P802.3cd RIN_OMA specs (comment 140, 141)

P802.3cd, March 2017, Vancouver BC
Jonathan King, Finisar

50GBASE-FR: RIN_OMA vs ER at $RIN_c = -135.5 \text{ dB/Hz}$

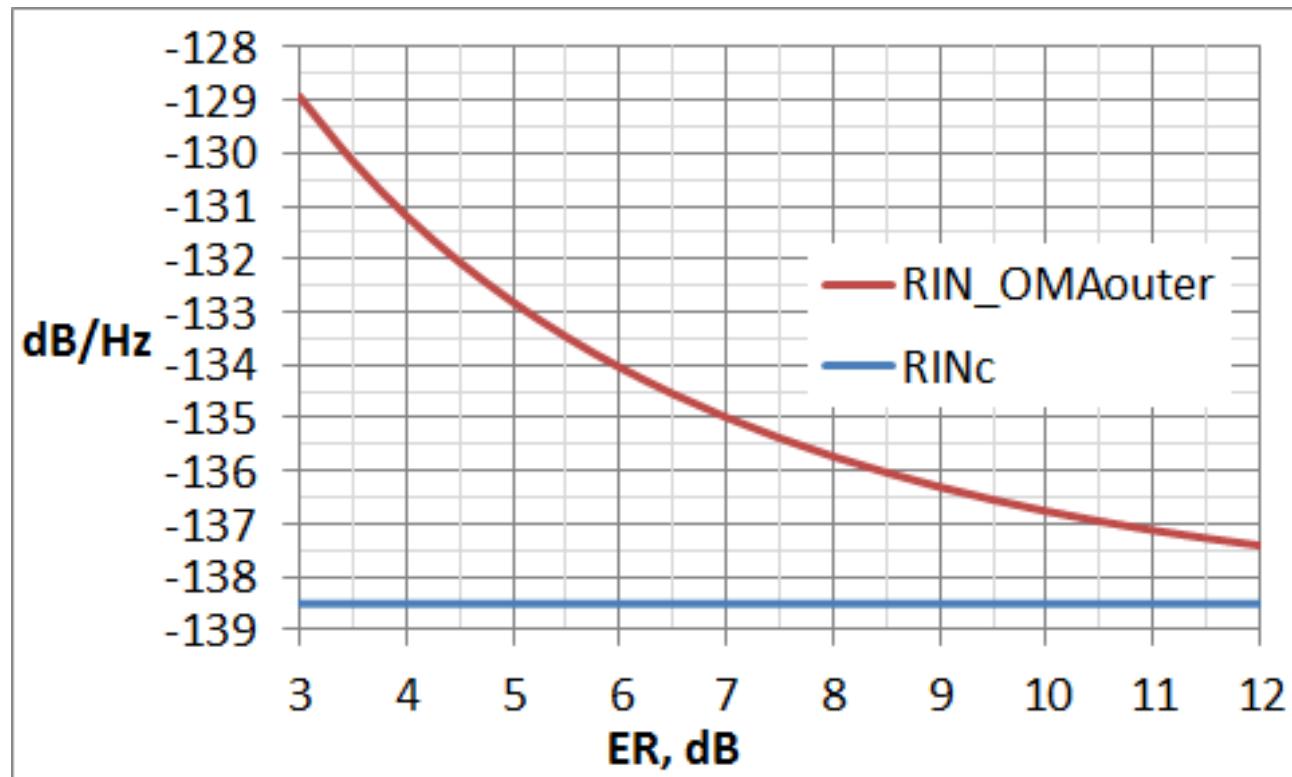
At a min ER = 4.5 dB, the required RIN_OMA equivalent would be -129 dB/Hz for 0.5 dB RIN penalty.

Propose backing off by ~3 dB to set the RIN_OMA spec at -132 dB/Hz for 50GBASE-FR and 50GBASE-LR

100GBASE-DR4: RIN_OMA vs ER at $RIN_c = -138.5 \text{ dB/Hz}$

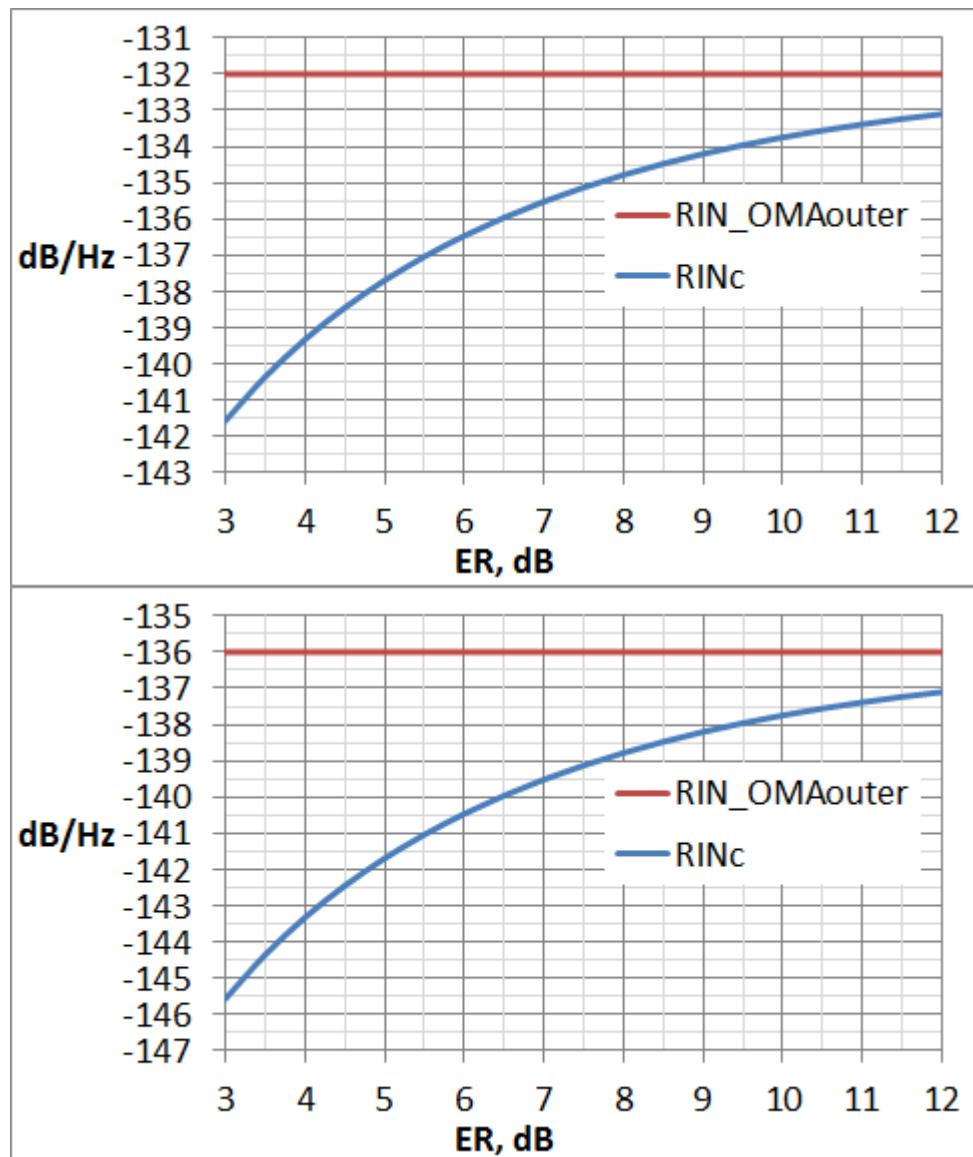
At a min ER = 5 dB, the required RIN_OMA equivalent would be -133 dB/Hz for 0.5 dB RIN penalty.

Propose backing off by 3 dB to set the RIN_OMA spec at -136 dB/Hz for 100GBASE-DR

- In 139.6.1, Table 139-6, change RIN_OMA max value to -132 dB/Hz for 50GBASE-FR and -LR
- In 140.6.1, Table 140-6, change RIN_OMA max value to -136 dB/Hz for 100GBASE-DR
- No changes to TDECQ or any other spec's
